**RE: ROBYN RELPH – 4966 STATIONHOUSE DRIVE  
SITE PLAN REVIEW  
TAX MAP NO. 98.09-1-6.000  
CPN No. 19-063  
MRB PROJECT No.: 0300.12001.000 PHASE 174**

MRB has completed a review of the submitted Site Plan regarding the above referenced project, dated August 9, 2019, prepared by Venezia Associates. We offer the following comments for the Planning Board's consideration. A brief written response to each comment should be provided by the design engineer.

## TYPICAL WATER SERVICE

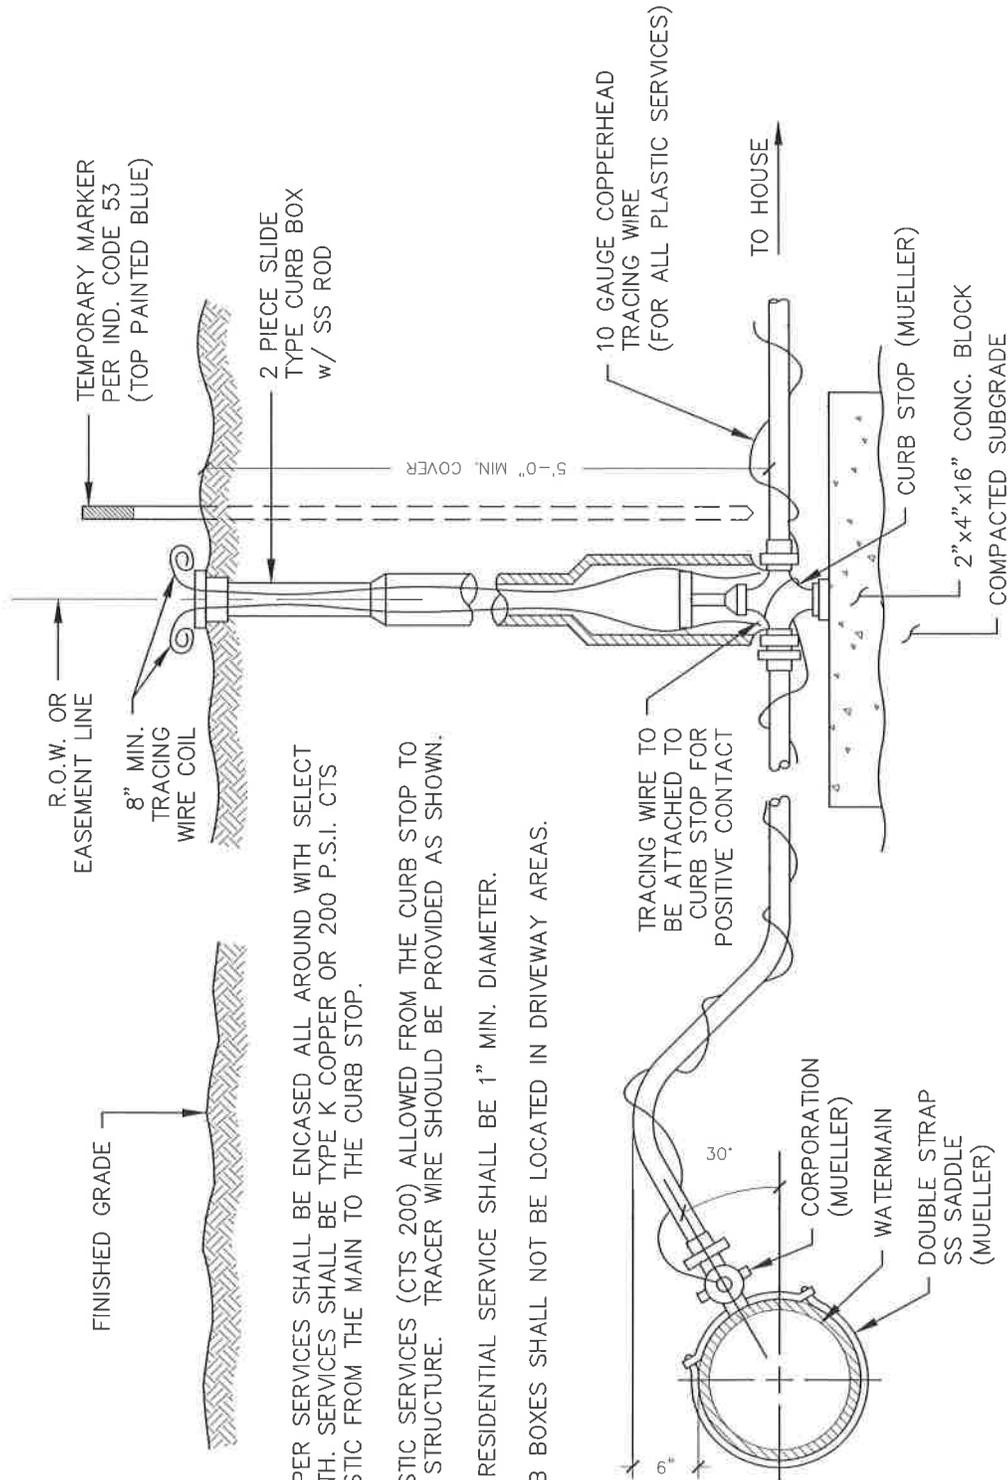
7. The plans should show the connection of the existing water service to the new building. The Town of Canandaigua Water Service Detail should be added to the plans.
